PERIODIC SAFETY INSPECTION REPORT NO. 2 – LOWER SLATE LAKE TAILINGS DAM

**Alaska Jurisdictional Dam No. AK00308
Kensington Mine, Alaska**

December 16, 2014

FIGURE 7

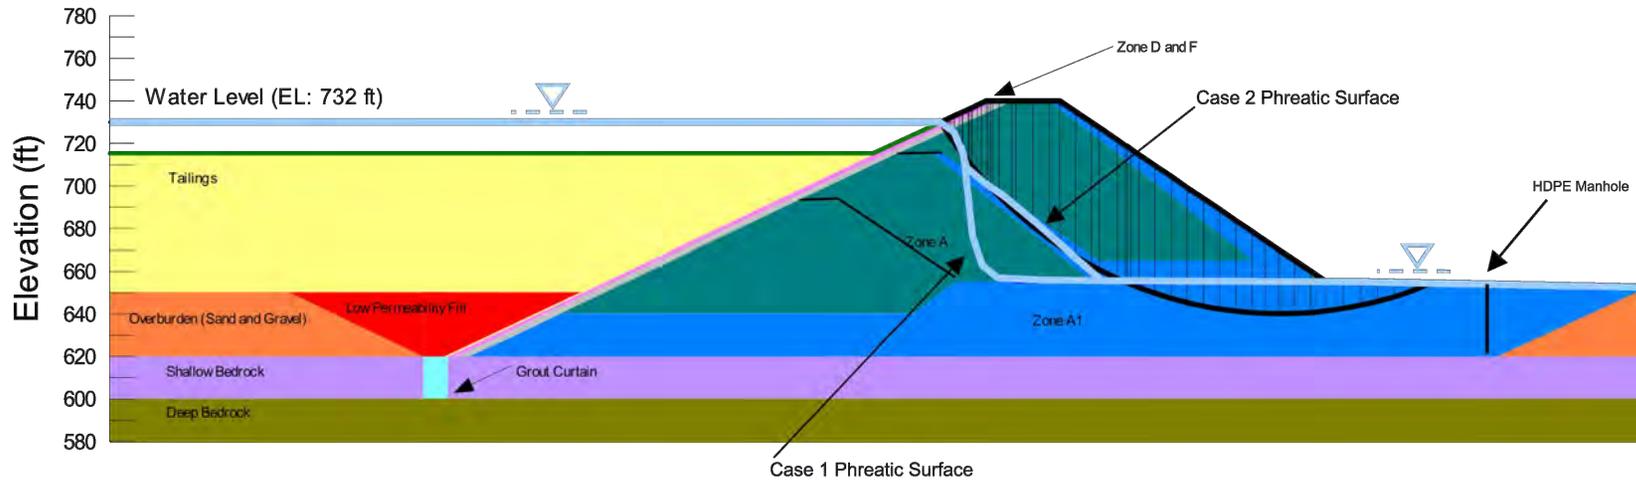
The results of the slope stability analyses are summarized in Figure 7 that also shows an example of the modeled section and downstream failure surface for the post-closure scenario. The factors of safety values were the same for the static and post-liquefaction condition for each scenario, which indicated the failure surface was not controlled by the tailings condition as the critical potential slip surfaces did not pass through the tailings. The factor of safety values ranged from 1.58 to 2.66; therefore, they were all greater than the minimum factor of safety for static pre-earthquake (1.5) and post-liquefaction (1.1). In contrast, the factor of safety values for the seismic stability scenarios were reported to be all less than one, but the evaluation actually only considered deformations and not the factor of safety.

FIGURE
 9

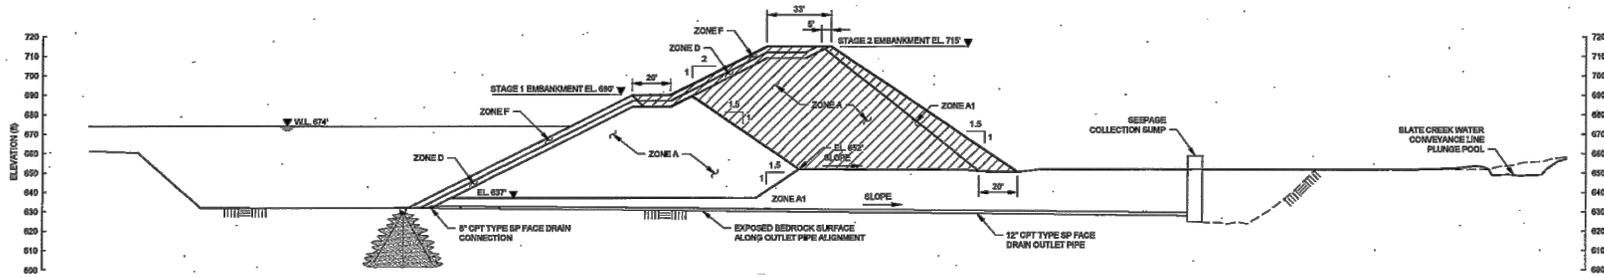
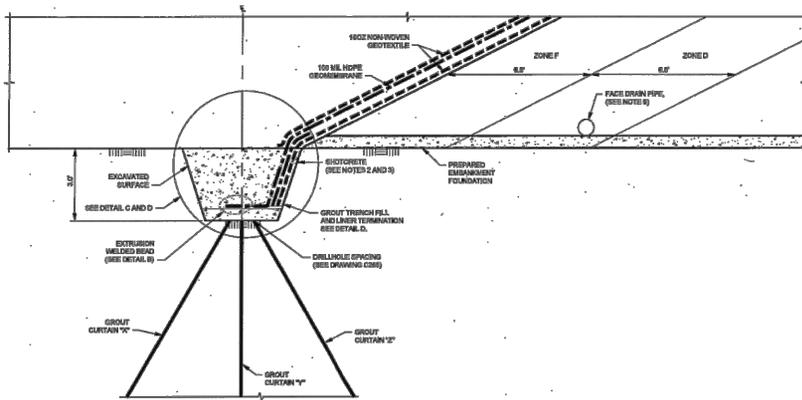
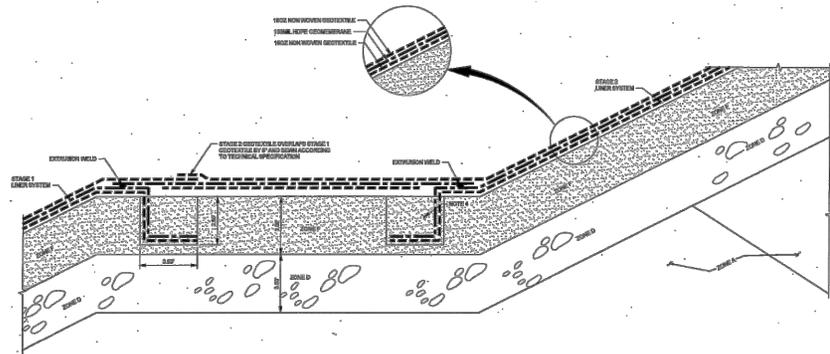
- The upstream toe at the left (east) abutment was realigned to coincide with the as-built Stage 2 grout trench. This realignment required about 60 feet of the upstream face to be constructed steeper than the designed 2H:1V slope with the steepest realigned slope section approximately 1.2H:1V. In addition, the as-built Stage 2 grout trench was only completed to an elevation of 710.5 feet, which is 1.5 feet above the spillway invert. The grout trench had to be terminated prematurely due to conflict with the exiting flume. The Stage 2 Construction Completion Report (KPL 2012H) does not provide details as to how the liner was completed above 710.5 feet at the left abutment, but field photographs seem to indicate it was left loose and not keyed in (see Figure 10).

- Revise the O&M Manual and EAP to include a description of the limited upstream east abutment trench that it is 4.5 feet lower than the dam crest elevation. Confirm and revise as necessary the maximum Stage 2 operating elevation to contain the 200-year storm (695 feet or 697.3 feet).

- As recommended in the KPL Construction Completion Report, the following issues should be resolved during the Stage 3 Dam design and construction:
 - Correct the upstream grout trench and continue it to the new design crest elevation

TITLE
SEEPAGE COLLECTION PUMP RATE, PIEZOMETER NEAR SUMP, AND LAKE LEVEL DATA

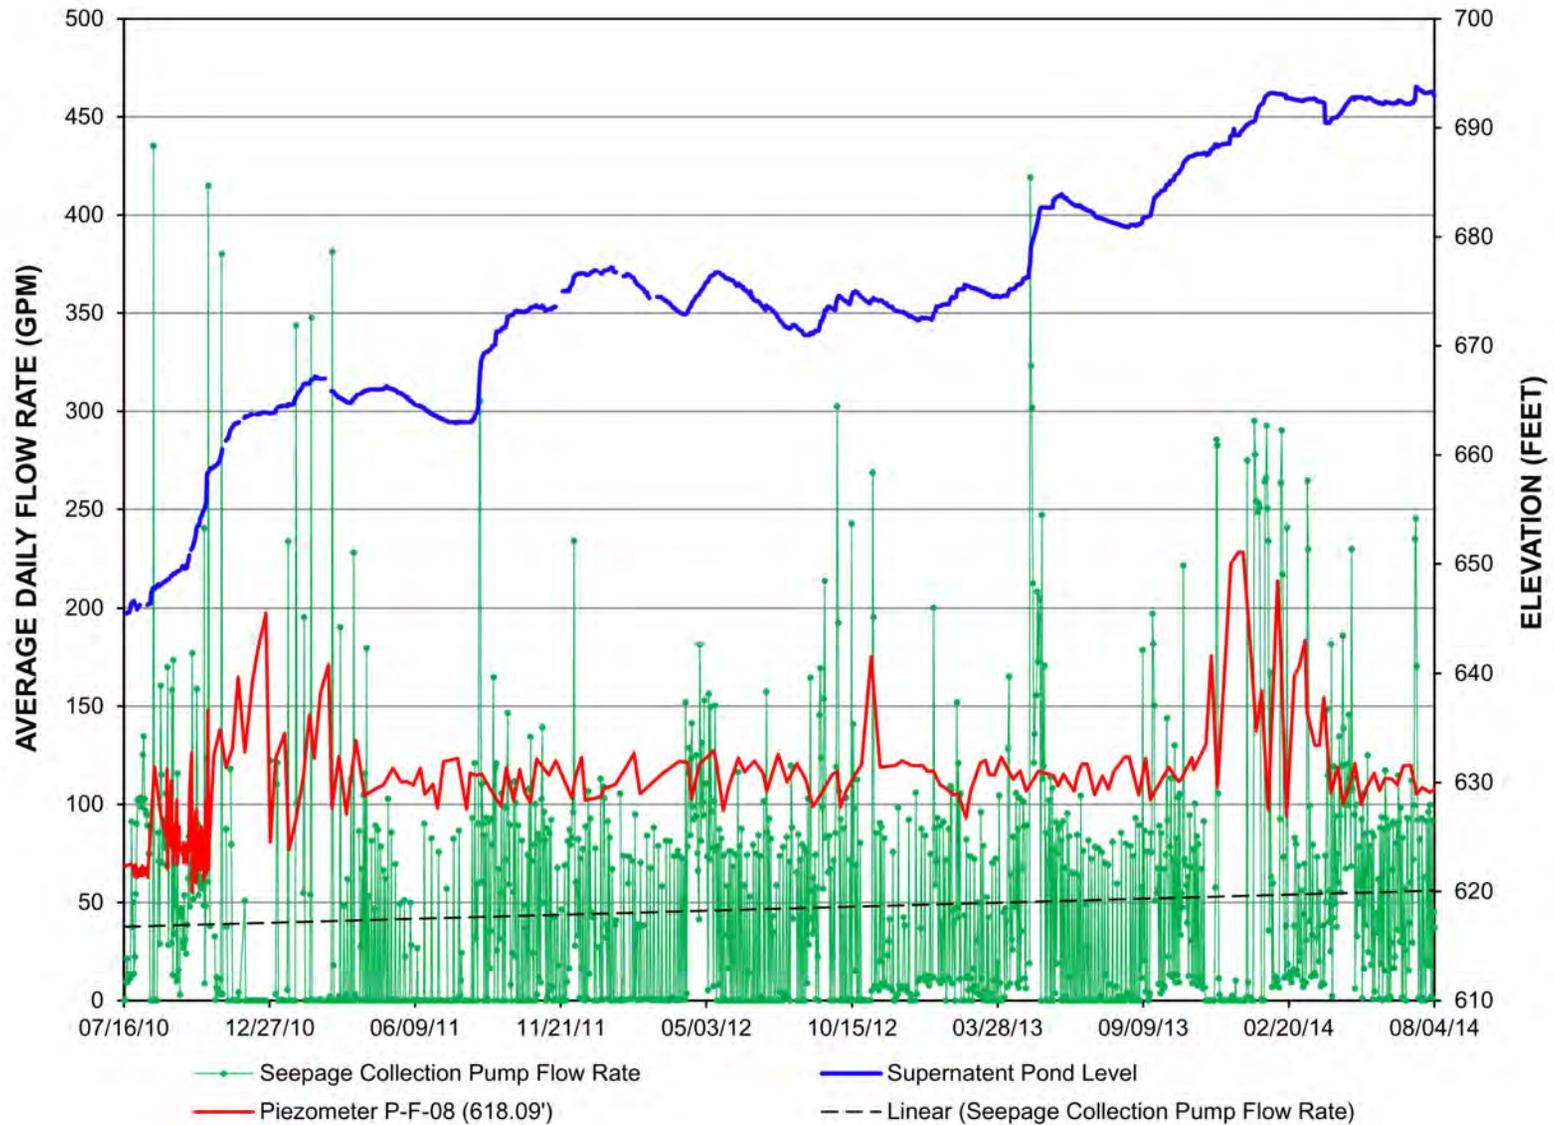
The seepage collection pump rate and lake level data is shown in Figure 15, which also shows the piezometer data for P-F-08 that is located near the sump. Similar to what was observed in the 2011 PSI report, the seepage pump rates tend to range between 0 and 250 gpm. The occasional spikes in the pump rate above 250 gpm are attributed to freezing pipes and pump shutdown.

As shown in Figure 15, the linear trendline for the seepage pump rate data, which is very scattered with an r-squared value of about 0.02, appears to show an increasing trend with time similar to the increasing lake level. The slope of linear trendlines for both the lake level and the seepage pumping rates are very similar looking for the data since about June 2011.
